In addition to responding to DPIE's RFI's in the letter of 08.06.21, this RTS includes a request for a plan swap to provide updated office elevations for warehouses 2A, 2C & 2D.

### 1. RFI response to DPIE's letter of 08.06.21

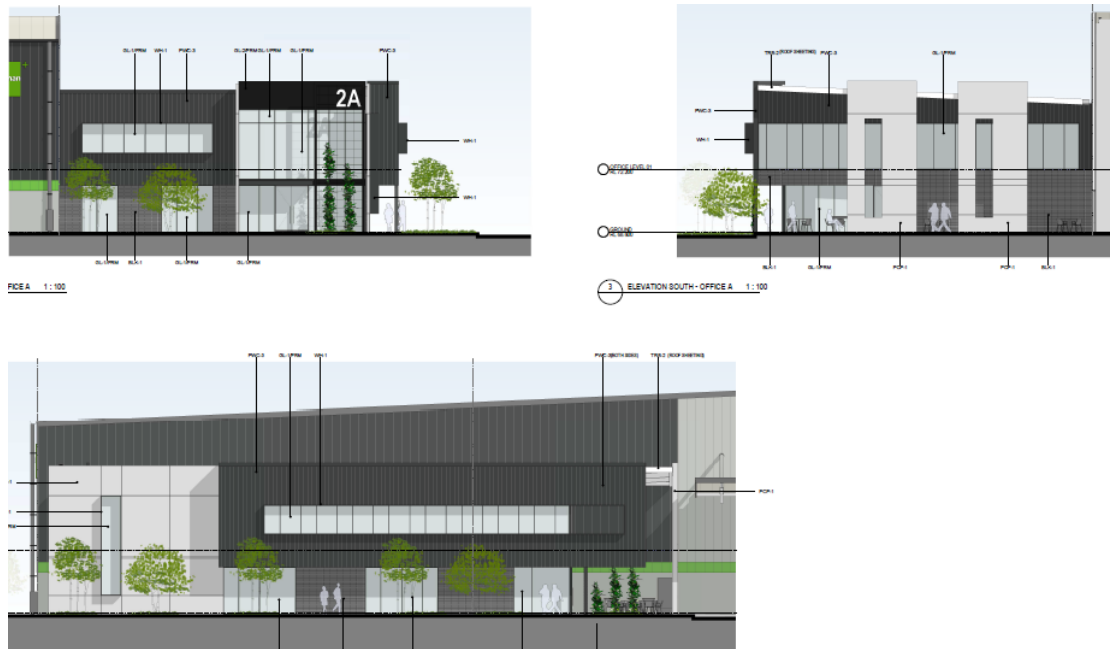
The Department notes that Building 2D would have a shared driveway for light and heavy vehicles, which raises concerns about traffic safety and manoeuvrability. Please provide justification for proposing a shared driveway and details of appropriate mitigation measures including, but not limited to, traffic control devices

- The site is constrained in nature, limiting the access opportunities for cars at Lot 2D, which is the reason for the proposed shared heavy and car access. This is largely due to the proposed Future Southern Link Road being on the south-east of the site and access from the side of the site would not be permitted from TrfNSW.

- Traffic generation for Lot 2D is estimated to be 9veh/hr (light and heavy vehicle combined), which is considered minimal and therefore not anticipated to result in unacceptable vehicle conflict between these vehicles in the slow speed environment.

- Warehouse 2D will provide only 55 on-site car parking spaces within a dedicated car parking area completely separated from operational loading bays (see below). Staff at Lot 2D including truck drivers and staff using the car park will receive detailed onsite briefing on best practices for car parking prior to the operation of the site, to advise of safe traffic management. Truck drivers will be provided with a 'Code of Conduct' and will be made aware of any possible conflict with the light vehicle movements. Traffic operational measures will be installed to uphold safety requirements. A Traffic Operational Management Plan will be completed.

- For these reasons any risk associated with vehicle conflicts is anticipated to be minimal and acceptable.
- See attached, **Appendix C**, traffic response prepared by ASON.

### **Submitted Lot 2A, Office A**

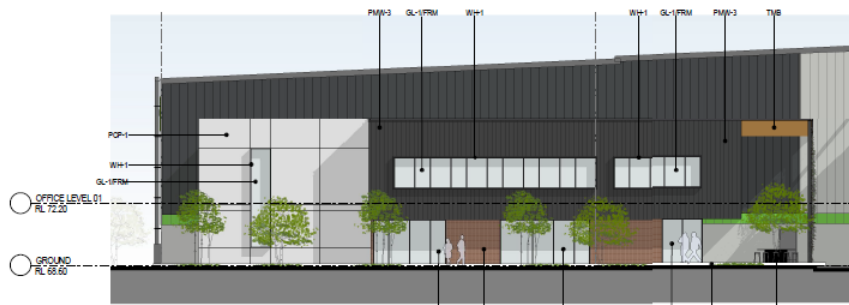
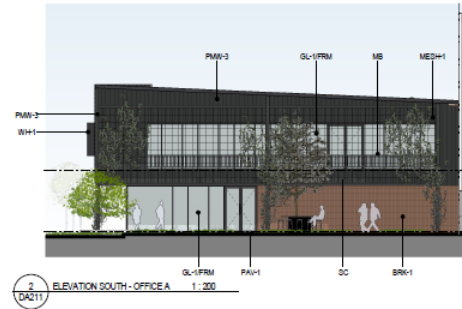
The facades of warehouse 2A, 2C & 2D are proposed to be updated from that submitted with the SSD application. The reason for the minor proposed updates are to bring the office elevations in line with the revised office designs and elevations for the estate and that of which is being sought as part of the local council, Building 3B development at the Estate. This will provide for a consistent design intent across the estate at all buildings where the office is yet to be completed will be updated to reflect a similar design intent.

- Change from blockwork to brickwork;
- Balcony provided to level 1 office areas;
- Extended awning providing significant shade over outdoor areas;
- Enhanced landscaping features including feature planting in outdoor areas and vines enclosing the outdoor areas
- Enclosed hood of office entry
